Addendum 1
Solicitation 24-99428
Brighton Beach Road Reconstruction

ADDENDUM #1, Thursday, April, 2024

Brighton Beach Road Reconstruction
City Project # 1940
BID No. 24-99428

SHEET NO. 12 OF 82 SHEETS

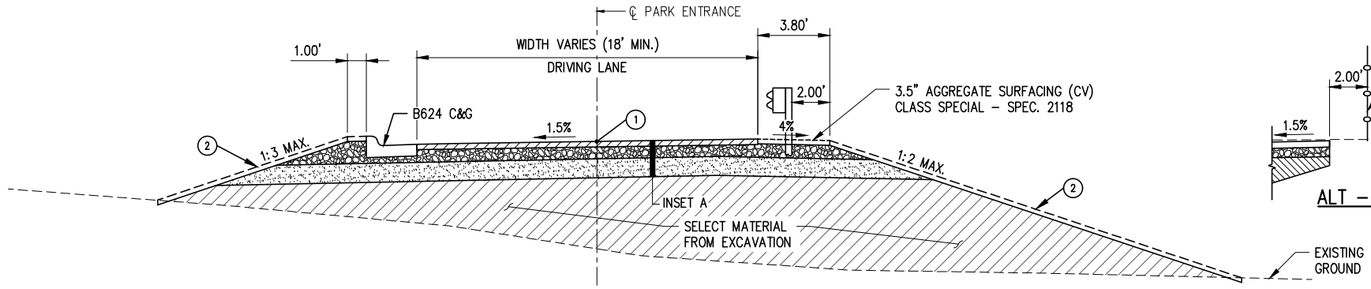
2. Drawing changes to the CONSTRUCTION CHARTS are as follows:
    a. Sheet 6; Modify Sheet 6 to add GRANULAR EMBANKMENT (CV) to Chart B.
    b. Sheet 7; Modify Sheet 7 to change GEOTEXTILE FABRIC TYPE 6 to TYPE 10 in Chart C.
    c. Sheet 8; Modify Sheet 8 to revise quantities in Chart F.
    d. Sheet 10; Modify Sheet 10 to revise sign quantities in Chart G.
    e. Sheet 12; Modify Sheet 12 to change GEOTEXTILE FABRIC TYPE 6 to TYPE 10 in Charts K & L.

SHEET NO. 14 OF 82 SHEETS

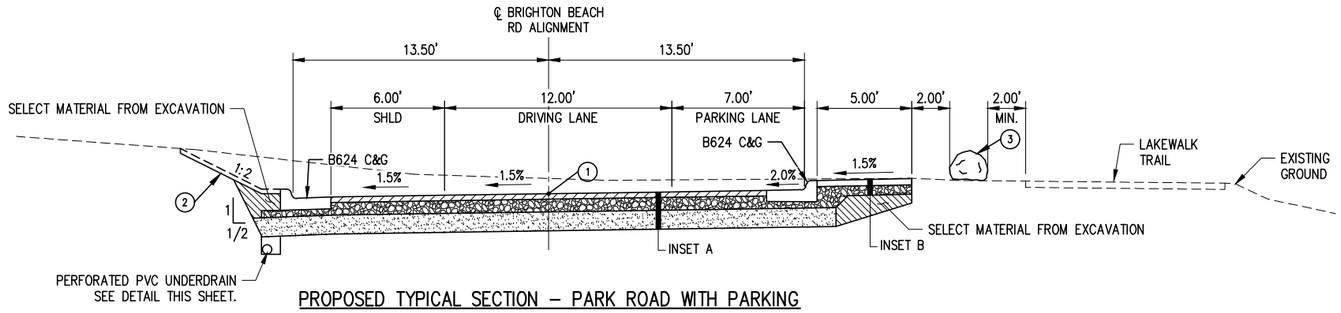
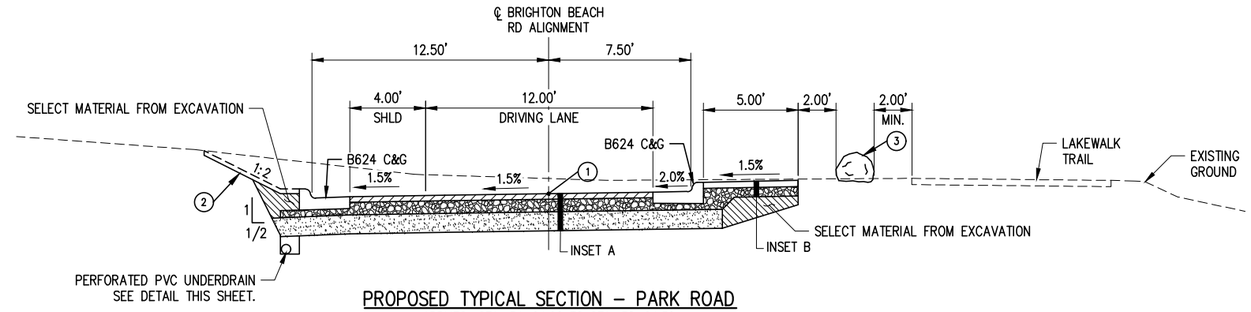
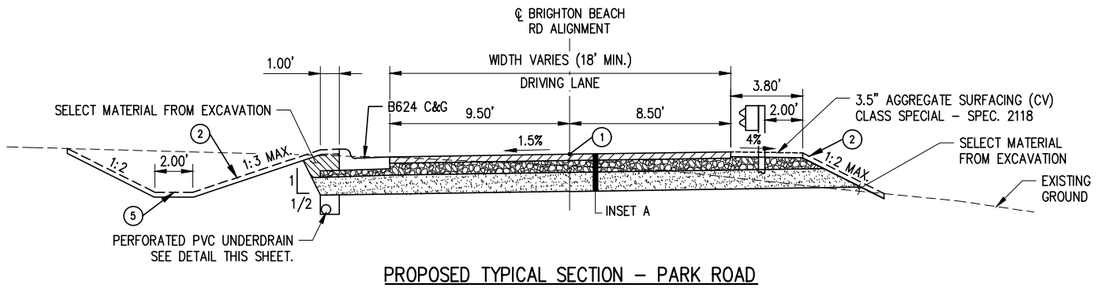
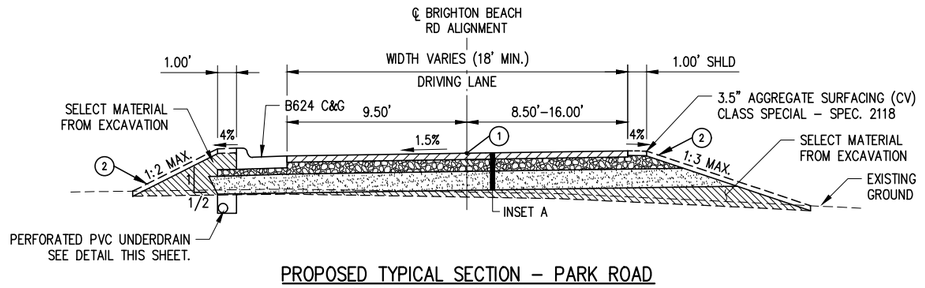
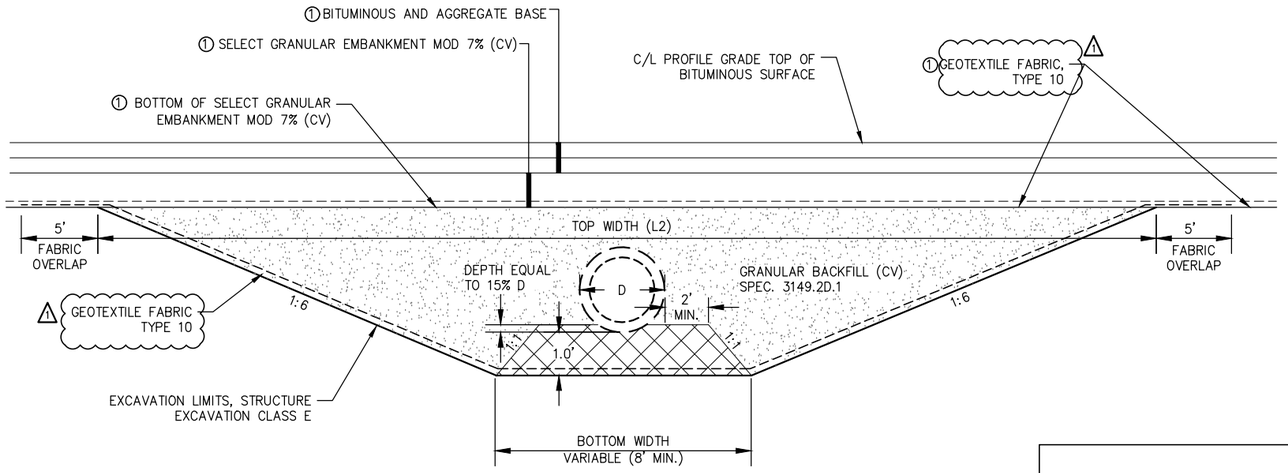
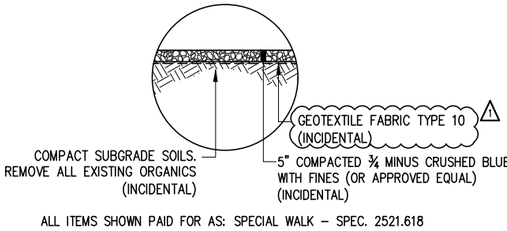
3. Drawing changes to the TYPICAL SECTIONS are as follows:
    a. Sheet 14; Modify Sheet 14 to change GEOTEXTILE FABRIC TYPE 6 to TYPE 10.

SHEET NO. 32 OF 82 SHEETS

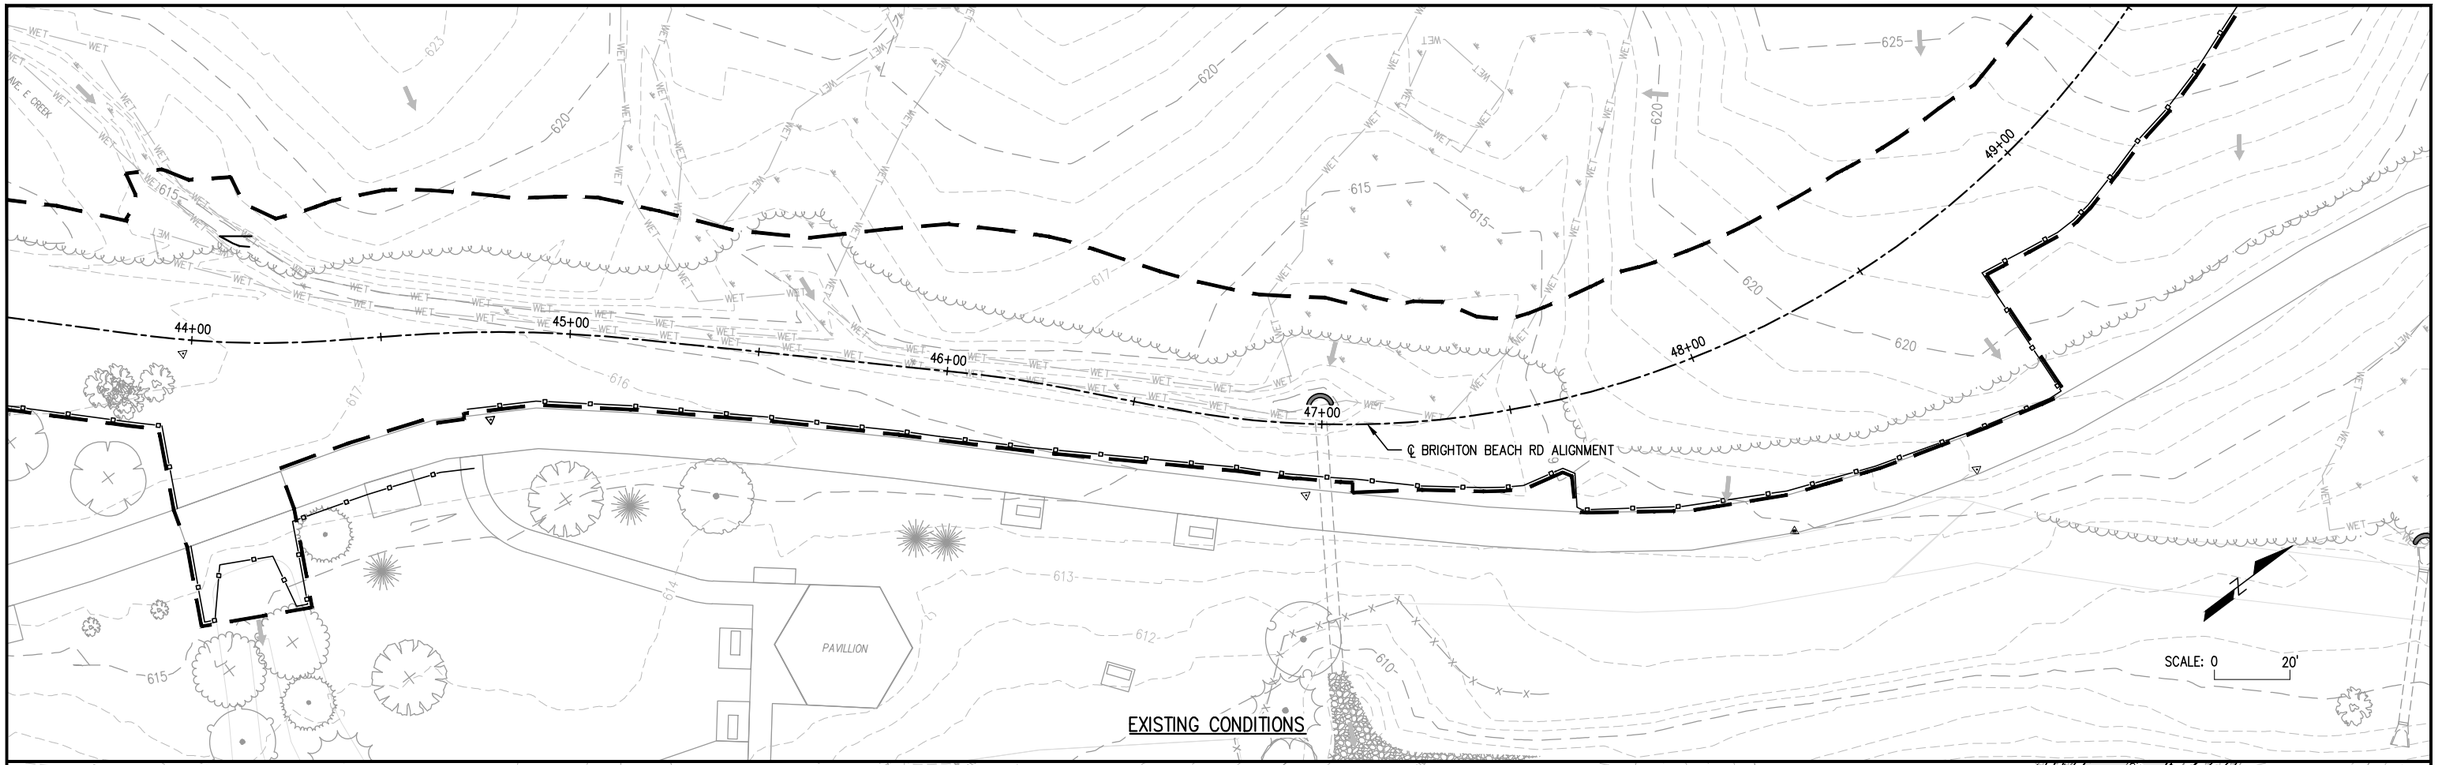
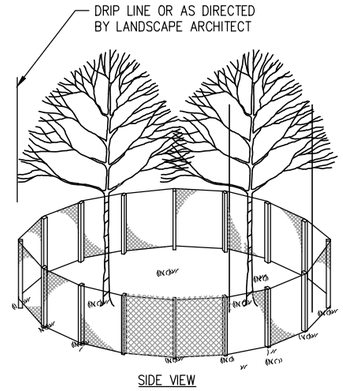
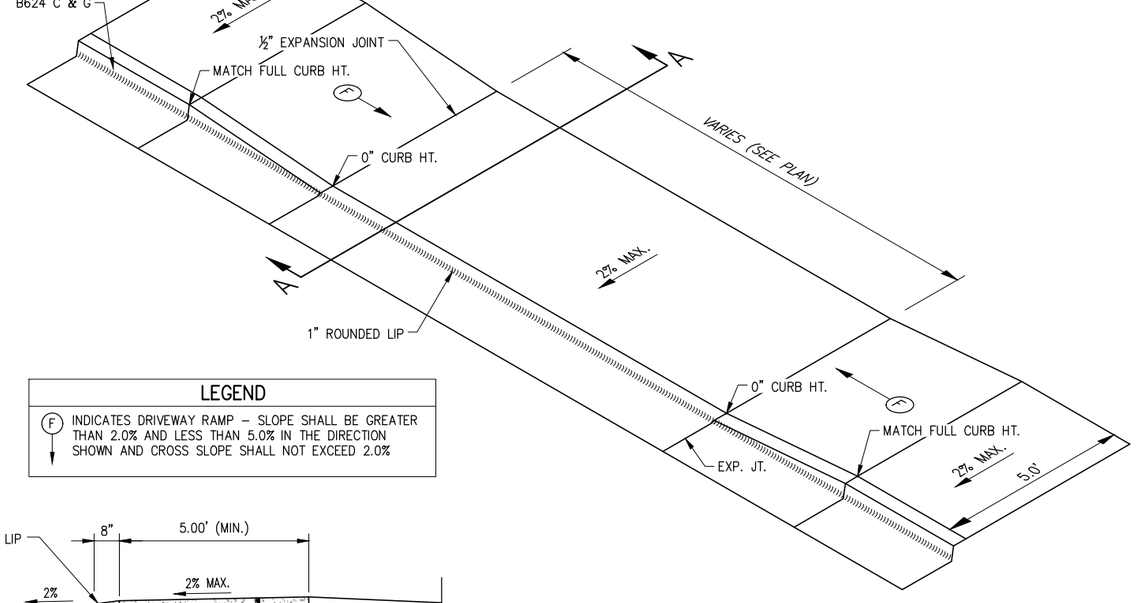
4. Drawing changes to the CONSTRUCTION DETAILS are as follows:
    a. Sheet 32; Modify Sheet 32 to change GEOTEXTILE FABRIC TYPE 6 to TYPE 10.

SHEET NO. 57 OF 82 SHEETS

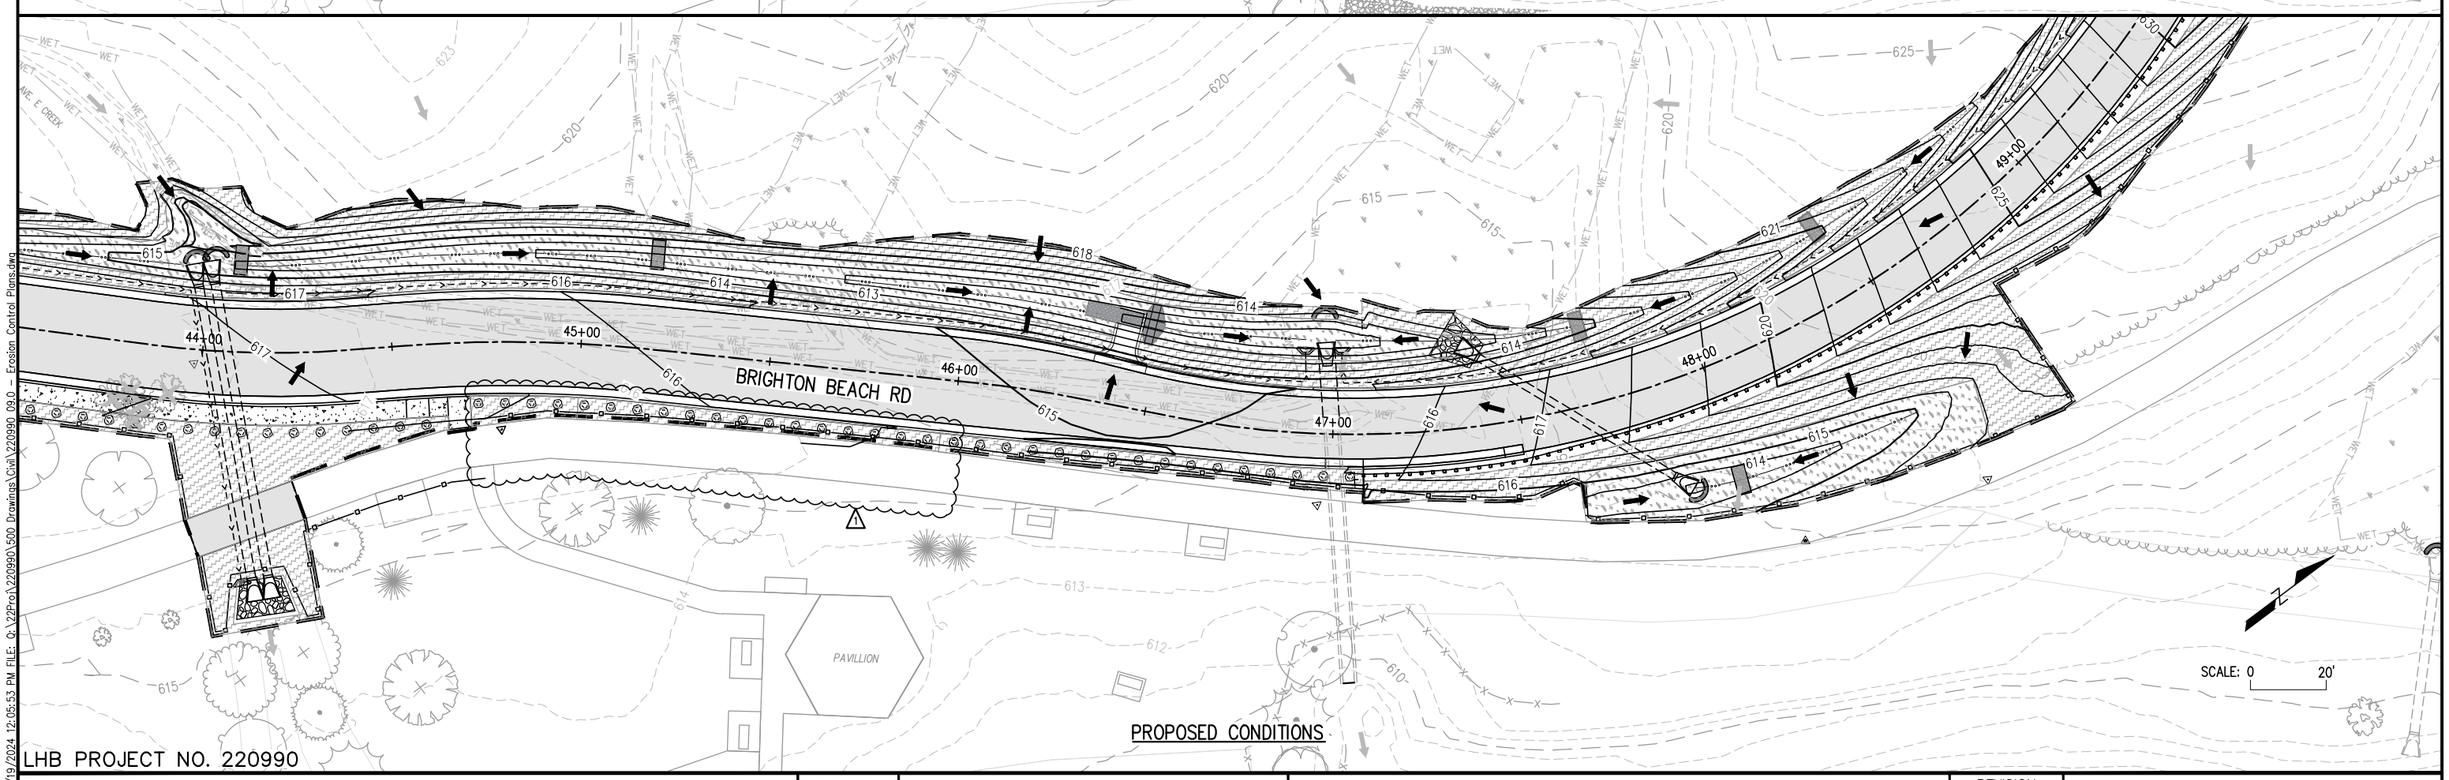
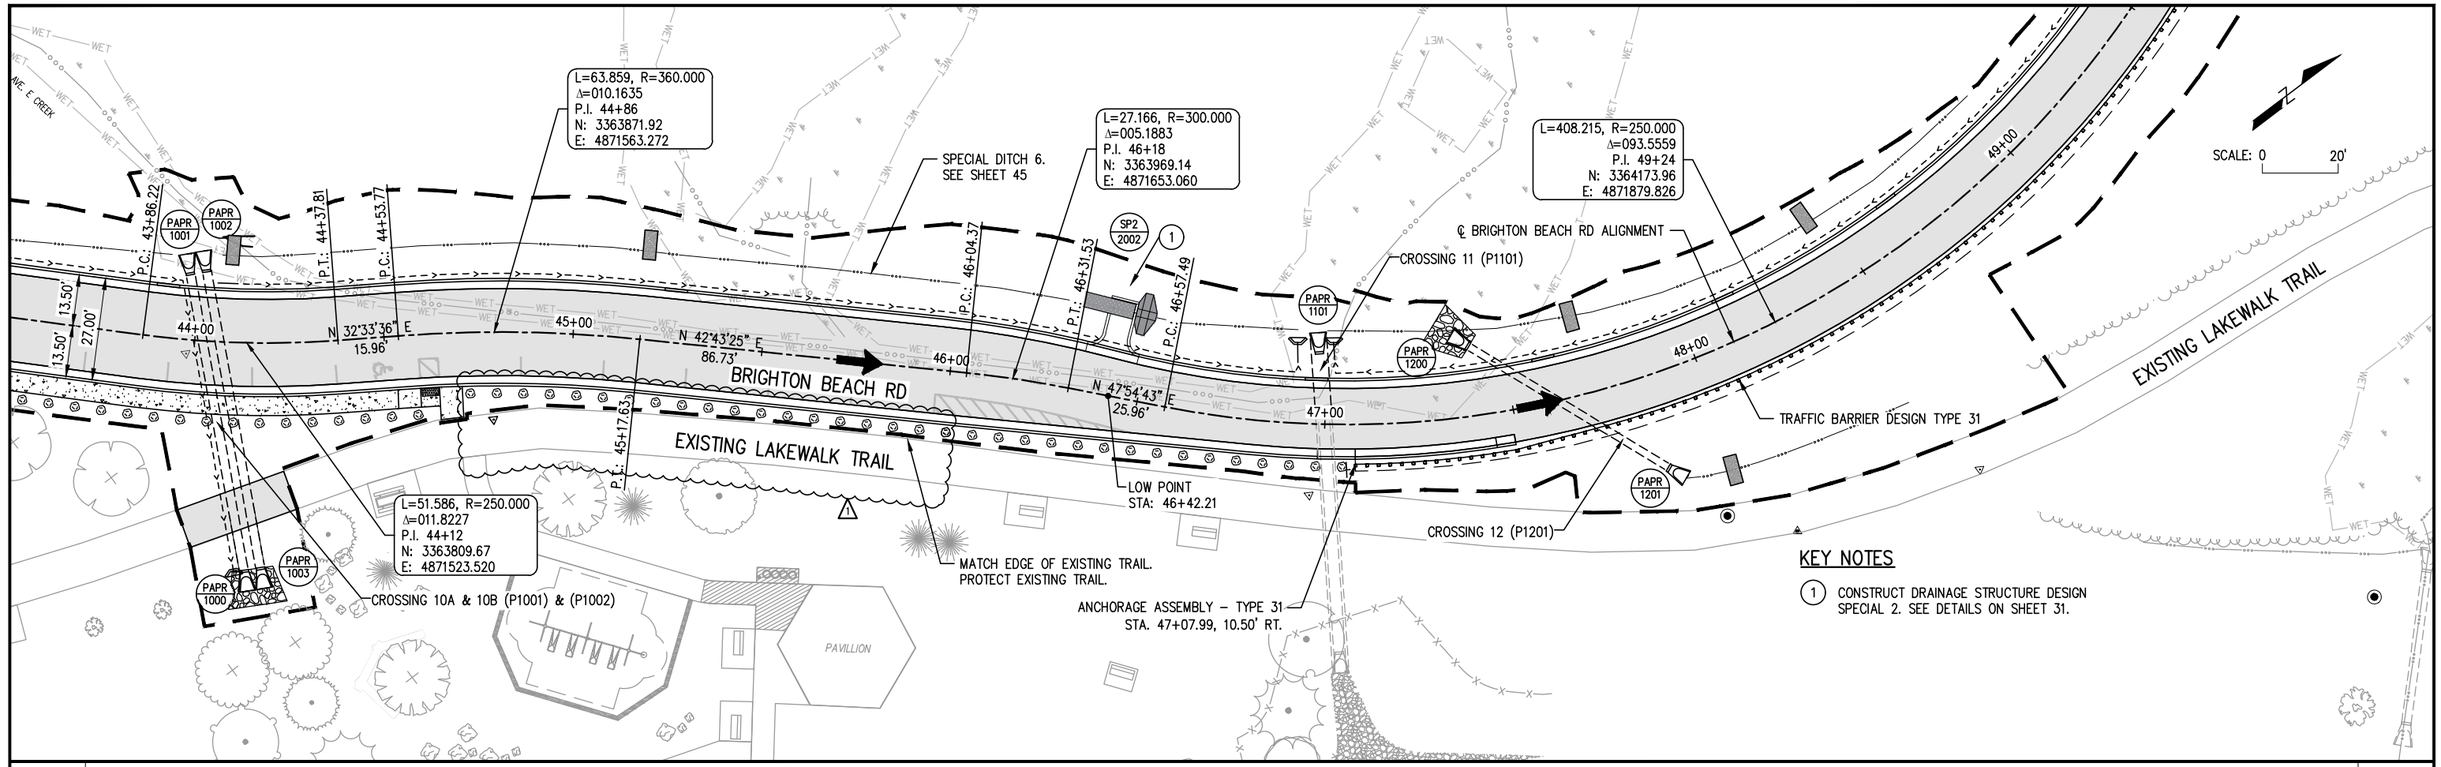
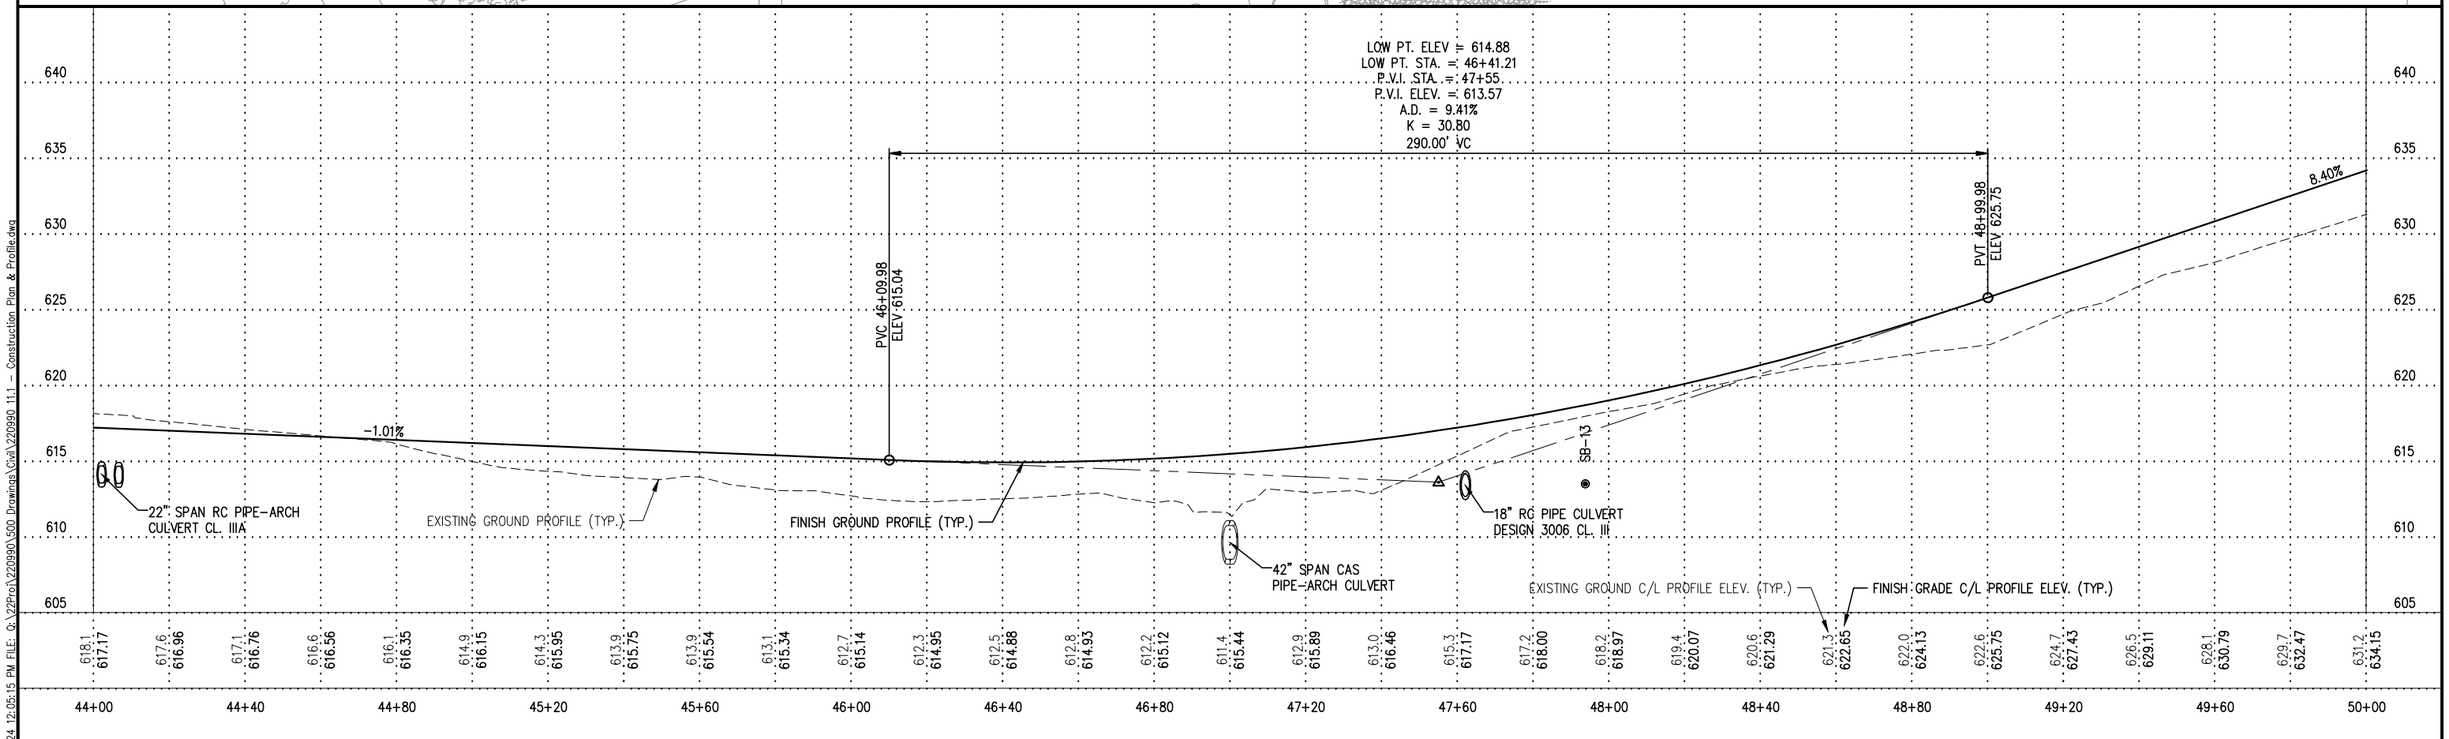
5. Drawing changes to the EROSION CONTROL PLANS are as follows:
    a. Sheet 57; Modify Sheet 57 to show removal of walk between Sta 44+70 and 46+00.
